Westinghouse
Electric Corporation

NTD-NRC-96-4630
DCP/NRC0453
Docket No: STN-52-003

SUBJECT: WESTINGHOUSE RESPONSES TO NRC REQUESTS FOR ADDITIONAL
INFORMATION ON THE AP600

Figure 440.482-1

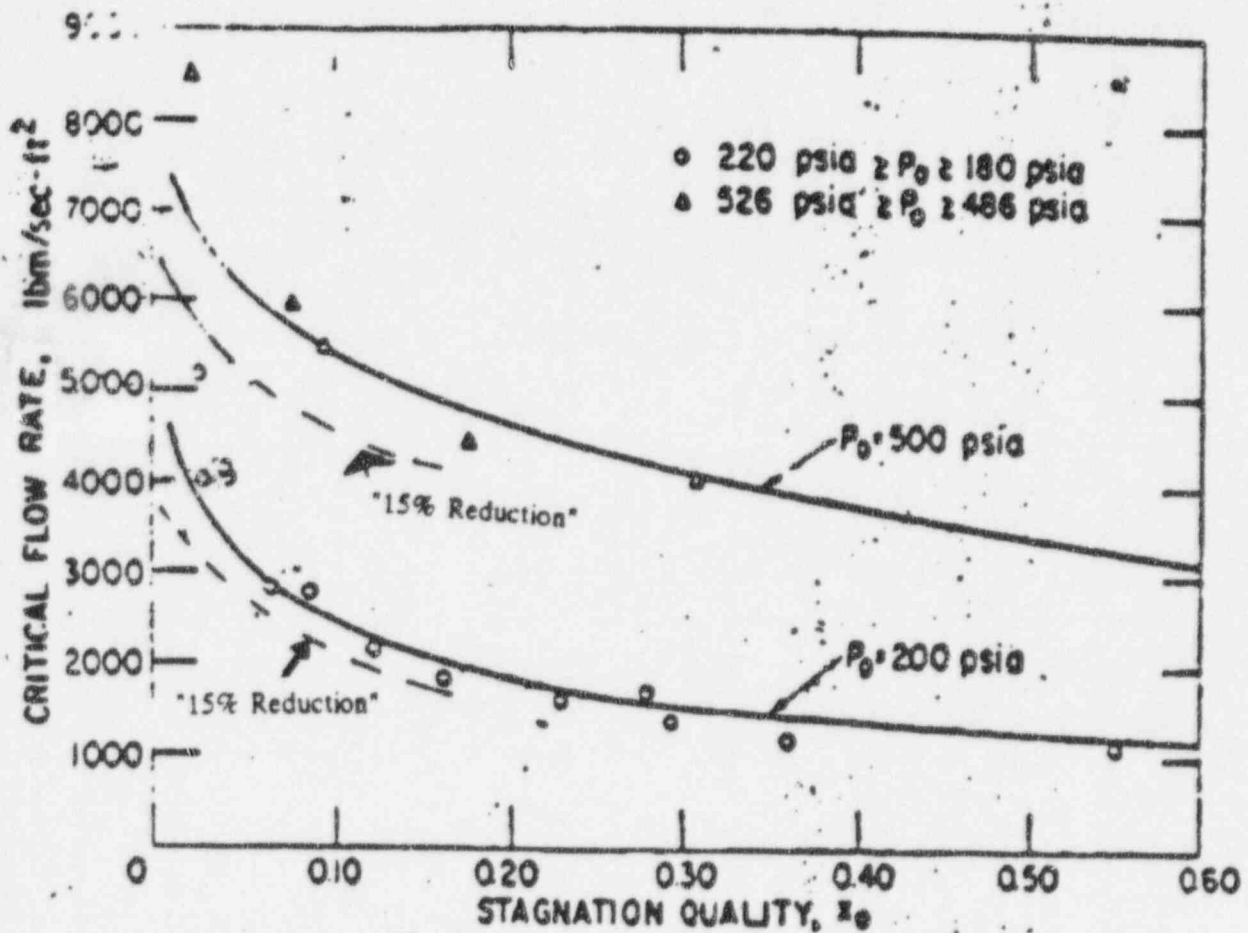
440.482 Please provide benchmark of the new critical flow model versus critical flow tests to justify and verify the coding changes. Also, please describe the model for unchoked conditions and explain how the model treats the transition from choked to unchoked conditions. Consider selected Marviken critical flow data for verifying the NOTRUMP code's ability to simulate subcooled, saturated two-phase, and single phase steam discharge.

The validity of these two models was assessed in the response to RAI 952.95 which documented the ADS 4 valve area sensitivity study. RAI 952.95 examined the uncertainty in the critical flow from these two models to assess the margin in the ADS stage 4 valves. The uncertainty was typically found to be approximately 15% for the models over a range of pressures and inlet enthalpies for different tests. Comparisons were taken from the literature as well as the original papers. Figures 440.482-1 to 440.482-6 were taken from Reference 440.482-2 for the Henry/Fauske model for the subcooled and low quality portion of the flow. The references given in the figure titles refer to the references given in Reference 440.482-2. The figures show the agreement of the Henry/Fauske correlation for difference sets of data and different fluids. Superimposed on these figures are the model predictions multiplied by 0.85 and/or 0.7 to indicate a 15% to 30% uncertainty of the model relative to the data. As the figures indicate, the Henry/Fauske model agrees very well with the data, usually within 15%.

Similar plots for the HEM model are given in Figures 440.482-7 to 440.482-9 from references 440.482-2 and 440.482-3. As the figures indicate, the HEM model agrees within 15% for the data shown.

The data comparisons given in Figures 440.482-1 to 440.482-7 do not cover the full pressure range for the AP600 small-break LOCA, but rather cover the low pressure portion of the transient. The NOTRUMP SPES and OSU comparisons provided in the preliminary validation reports provide additional validation over the higher pressure range from 2250 psia down to 140 psia which overlaps with the data comparisons given in Figures 440.482-1 to 440.482-9. The method used for the SPES and OSU comparisons to the NOTRUMP predictions with the Henry/Fauske - HEM critical flow model was to use the integrated flow measurements from the beginning of the test, until the ADS stage 1 valve opened. The integrated flow (lbms) was divided by the time to reach ADS stage 1 to obtain an average mass flowrate out the break. The earlier of either the data or the prediction was used for the ADS stage 1 opening time for a given test. By using the integrated break flow data over this time period, the only flow path out of the system was through the break. Also, by selecting the time period before ADS stage 1, the additional complications of timing differences between the code and the data and a more complex mass distribution within the primary system are avoided. Figure 440.482-10 shows the comparison of the average break flow predicted by the NOTRUMP code and the measured average flow rate. Figure 440.482-11 shows the ratio of the measured flowrate to the predicted flowrate for the different tests. Both figures indicate that the combined Henry/Fauske - HEM model represents the critical flow with the similar uncertainties as the comparisons with the original data. The poorest comparison was the tests SB10, the double-ended cold line balance line break. If the measured-to-predicted
